## Product Change Notice (PCN)

PCN Number: **PCN-0451143R-01**

Product(s) Affected: PJ-035DH

PREVIOUS CUI DEVICES DETAIL / IMAGE	NEW CUI DEVICES DETAIL / IMAGE

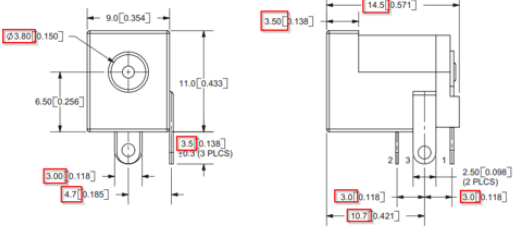
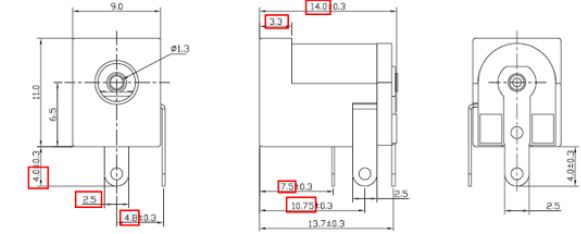
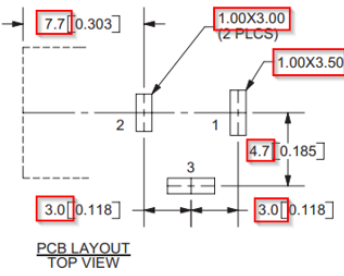
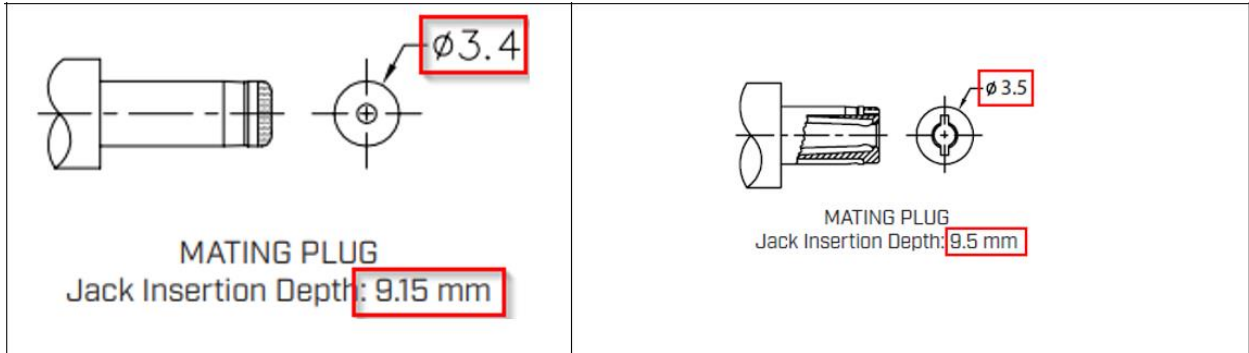
Description of Change: mechanical, and material differences as shown below:

<table border="1"> <thead> <tr> <th></th> <th>MATERIAL</th> <th>PLATING</th> </tr> </thead> <tbody> <tr> <td>center pin</td> <td>copper</td> <td>nickel</td> </tr> <tr> <td>terminal 1</td> <td>brass</td> <td>silver</td> </tr> <tr> <td>terminal 2</td> <td>copper alloy</td> <td>silver</td> </tr> <tr> <td>terminal 3</td> <td>brass</td> <td>silver</td> </tr> <tr> <td>plastic</td> <td>PBT</td> <td></td> </tr> </tbody> </table>		MATERIAL	PLATING	center pin	copper	nickel	terminal 1	brass	silver	terminal 2	copper alloy	silver	terminal 3	brass	silver	plastic	PBT		<table border="1"> <thead> <tr> <th>DESCRIPTION</th> <th>MATERIAL</th> <th>PLATING/COLOR</th> </tr> </thead> <tbody> <tr> <td>center pin</td> <td>brass</td> <td>nickel</td> </tr> <tr> <td>terminal 1</td> <td>brass</td> <td>silver</td> </tr> <tr> <td>terminal 2</td> <td>bronze</td> <td>silver</td> </tr> <tr> <td>terminal 3</td> <td>brass</td> <td>silver</td> </tr> <tr> <td>cover</td> <td>PBT (UL94V-0)</td> <td>black</td> </tr> <tr> <td>housing</td> <td>PBT (UL94V-0)</td> <td>black</td> </tr> </tbody> </table>	DESCRIPTION	MATERIAL	PLATING/COLOR	center pin	brass	nickel	terminal 1	brass	silver	terminal 2	bronze	silver	terminal 3	brass	silver	cover	PBT (UL94V-0)	black	housing	PBT (UL94V-0)	black

MATERIAL	PLATING																																						
center pin	copper	nickel																																						
terminal 1	brass	silver																																						
terminal 2	copper alloy	silver																																						
terminal 3	brass	silver																																						
plastic	PBT																																							
DESCRIPTION	MATERIAL	PLATING/COLOR																																						
center pin	brass	nickel																																						
terminal 1	brass	silver																																						
terminal 2	bronze	silver																																						
terminal 3	brass	silver																																						
cover	PBT (UL94V-0)	black																																						
housing	PBT (UL94V-0)	black
